**ADDENDUM NO. 2**

**DATE:** September 25, 2020

**Request for Bids Specification No. ES20-0001F**

**Stormwater & Wastewater Sewer Replacement Project (Various Areas): S Wright Ave, N Carr St, N Karl Johan Ave, S 9th St, N 12th St, N 26th St, & S 53rd St**

SHEET 3 OF 8

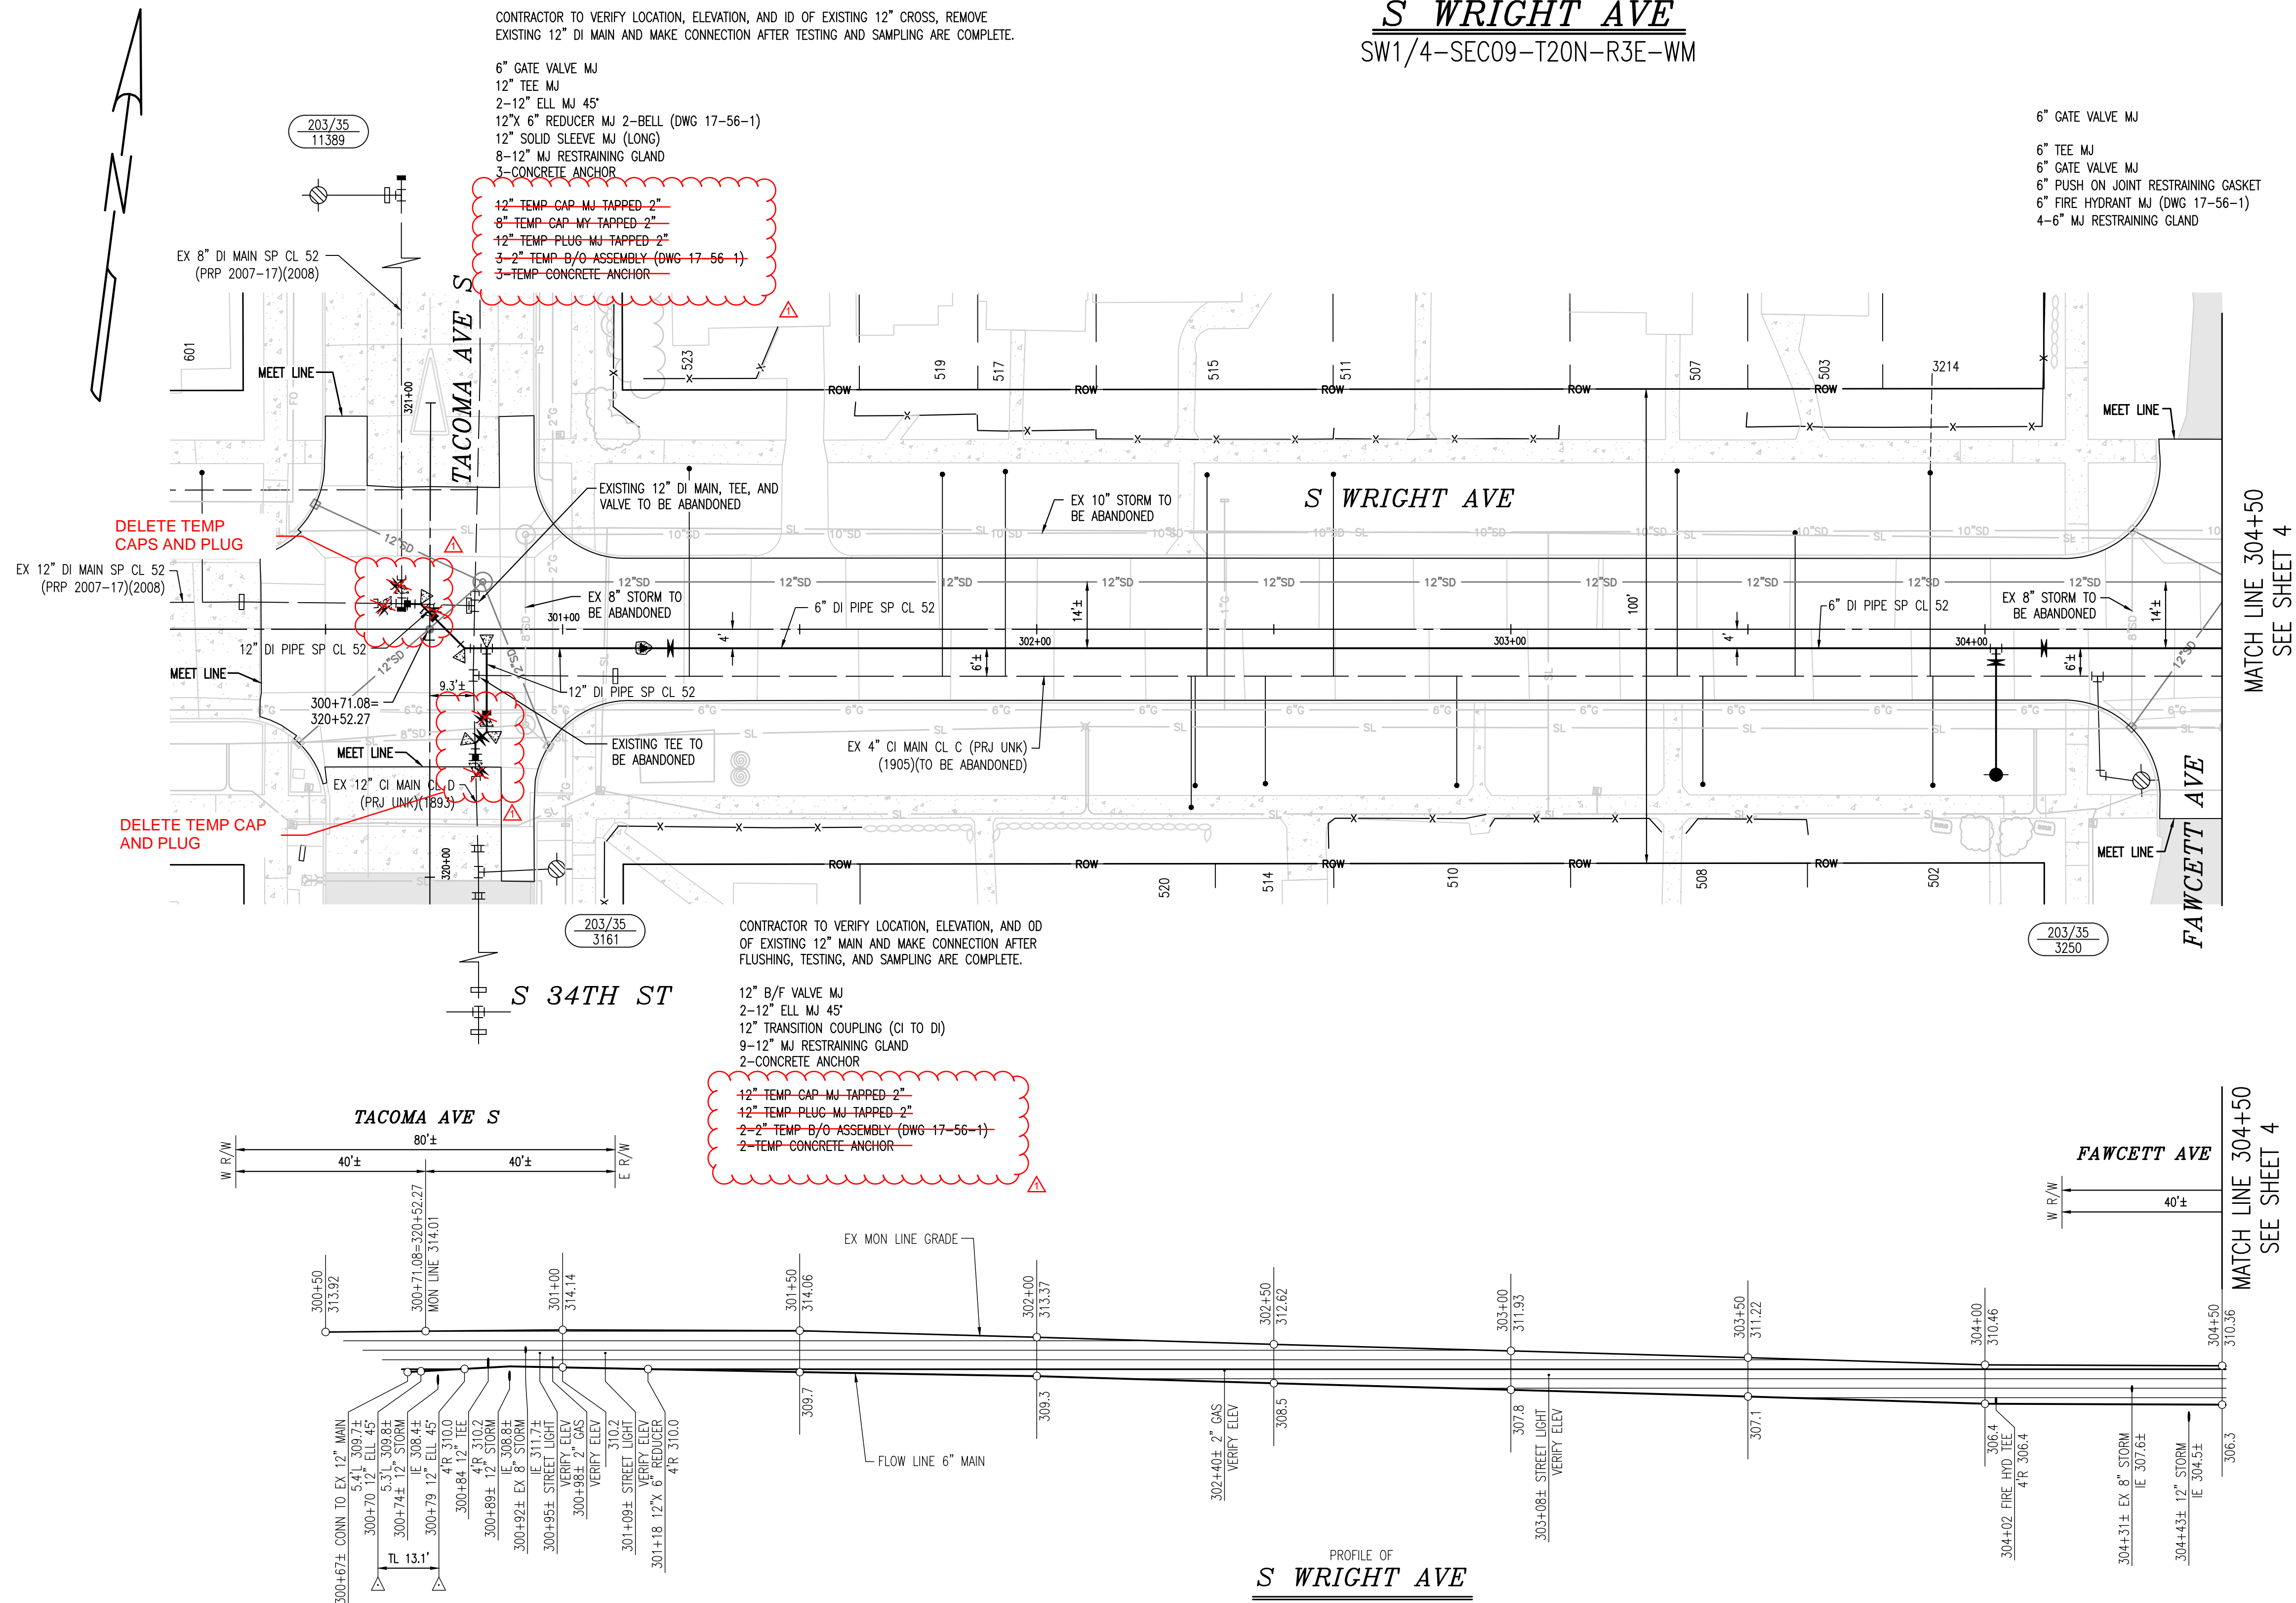
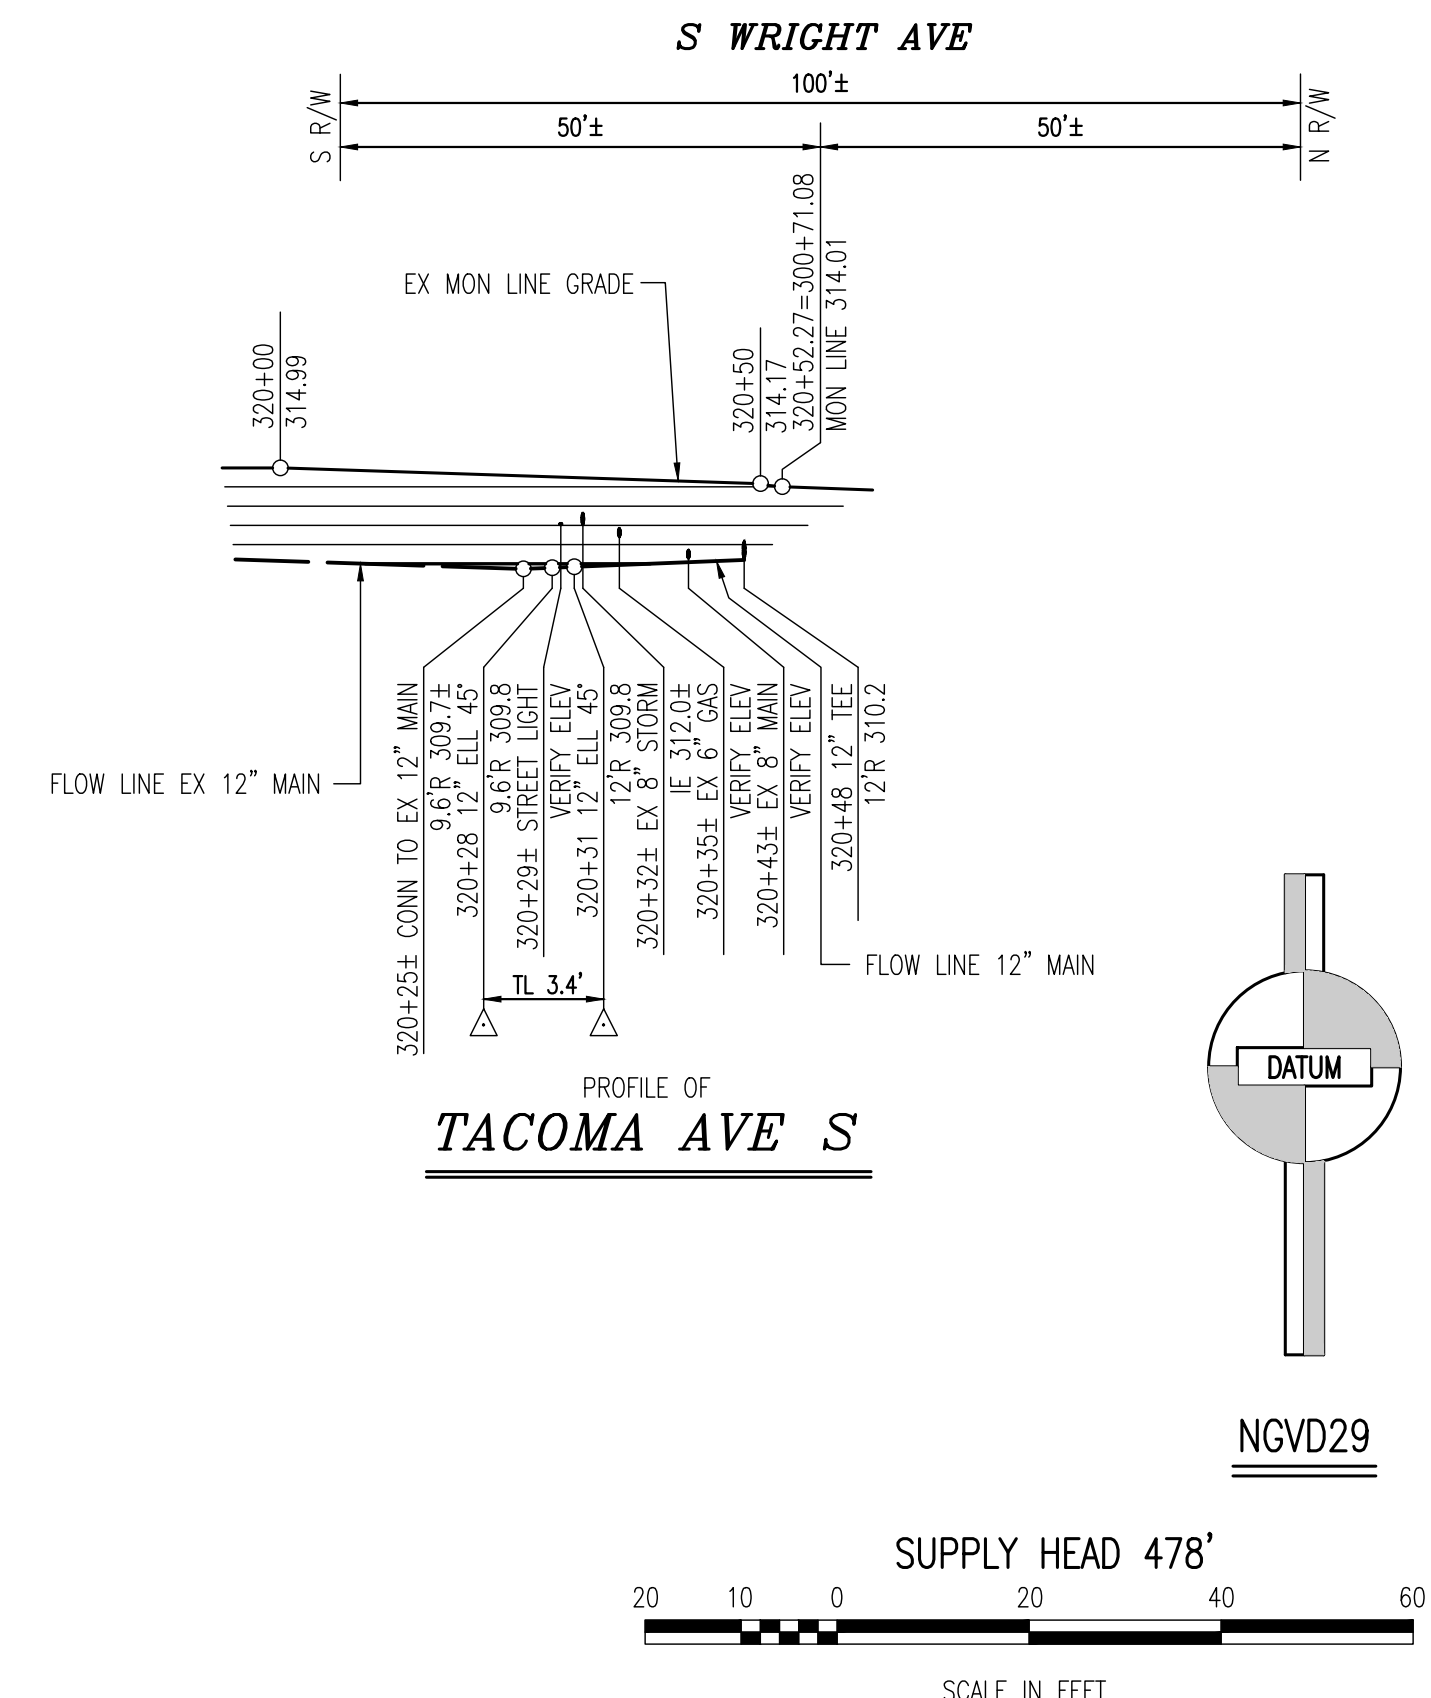
DELETE TEMP CAP

REPLACE TEMP PLUG  
WITH TEMP CAP

DELETE TEMP CAP  
AND TEMP PLUG

N KARL JOHAN AVE

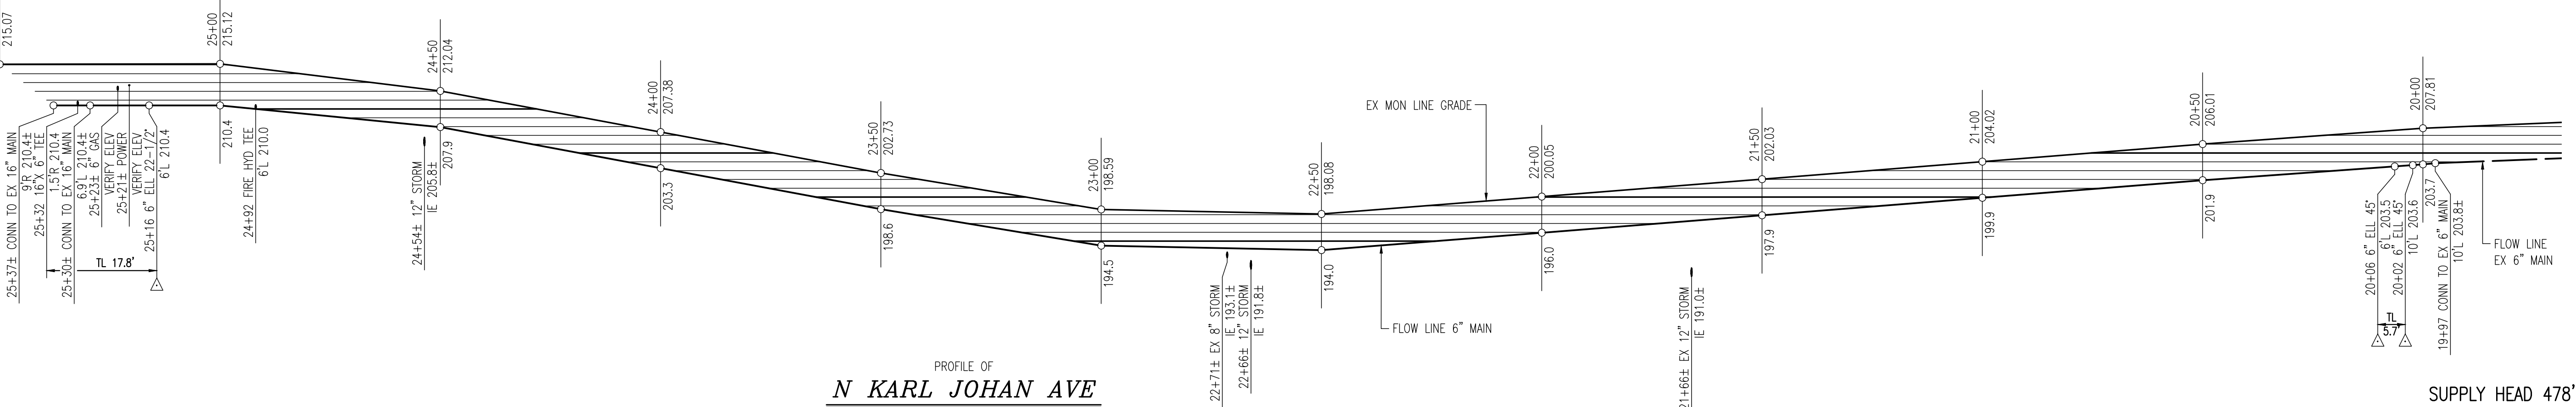
DELETE TEMP PLUG AND TEMP CAP
